AGENDA PLANNING COMMISSION OF THE CITY OF WHITE BEAR LAKE, MINNESOTA MONDAY, FEBRUARY 28, 2022 7:00 P.M. IN THE CITY HALL COUNCIL CHAMBERS

То:	The Planning Commission
From:	Samantha Crosby, Planning & Zoning Coordinator
Date:	February 28, 2022
Subject:	Pitlick Residence Expansion / 4264 Cottage Park Road / Case No. 22-2-V

Tyler and Sara Pitlick are requesting a 31.5 foot variance from the 35 foot street-side setback in order to expand the single-family residence northward by 22 feet. The variance would allow the west wall of the addition to be 3.5 feet from the street side property line and the roof is designed with a 3 foot wide eave overhang.

City of White Bear Lake

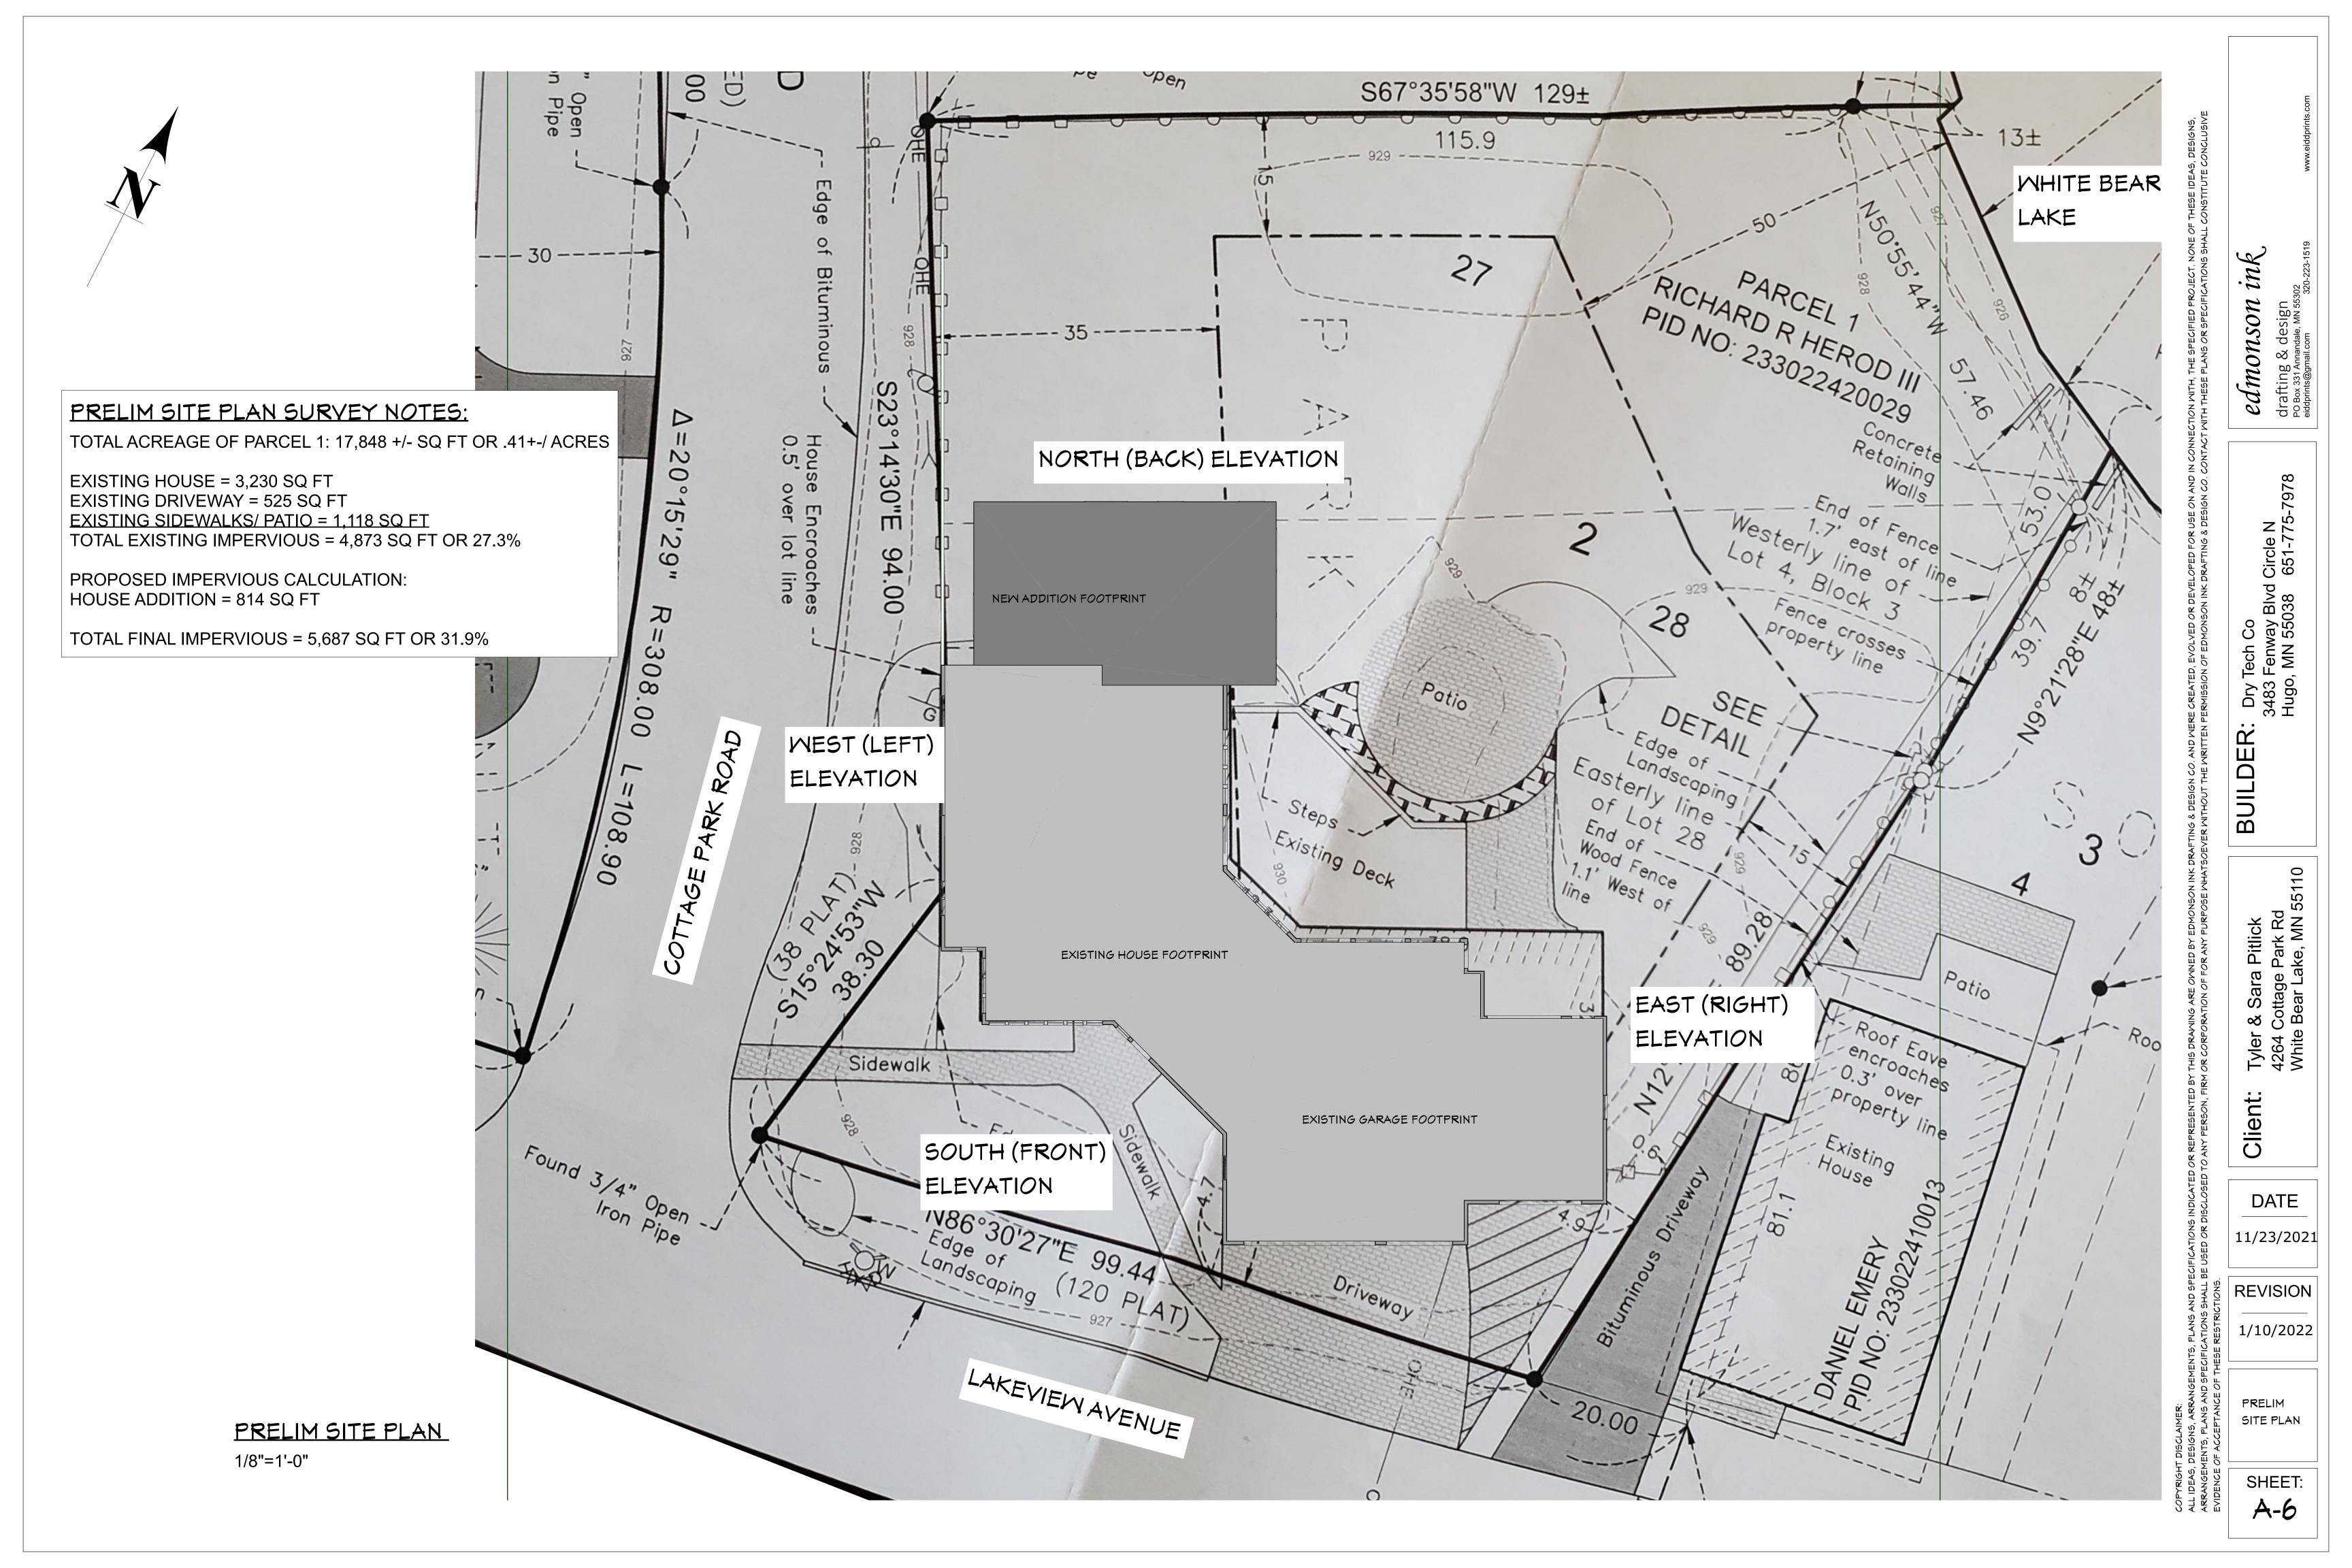
With the edge of the eave overhang being half a foot from the property line, the proposal provides very little setback. Is the setback the minimum necessary to alleviate the practical difficulty? Staff doesn't believe that it is. Pushing the proposed addition eastward would not encroach upon the existing deck or patio. While the proposed floor plan would likely need to be redrawn, there is plenty of space to both the north and the east should the shape of the addition need to change slightly in response to rearranging the floor plan to accommodate a setback that is more comparable with the established norm for the neighborhood.

Because the impervious area limitation would exceed 30%, the applicant would need to mitigate the impervious area by installing a rain garden or other infiltration feature per code. The feature will be relatively small so there is plenty of space to accomplish this on site. The addition should also be guttered to capture run-off from the roof and direct it away from the public right-of-way.

Because the applicant has not provided a practical difficulty as to why the addition cannot be designed to provide a greater amount of setback, more commensurate with the immediate neighborhood, staff recommends denial.

1. The project has not been proven necessary for the reasonable use of the land or building; alternative design options exist.

- 2. The request is not the minimum necessary to alleviate a practical difficulty.
- 3. The non-conforming use of neighboring lands, structures, or buildings in the same district would be the sole ground for issuance of the variance.
- 4. The proposal does not maintain the essential character of the immediate neighborhood because it is not in keeping with the average.
- 5. The granting of the variance would not be in harmony with the general purpose and intent of the code deviation from the code without reasonable justification will slowly alter the City's essential character.
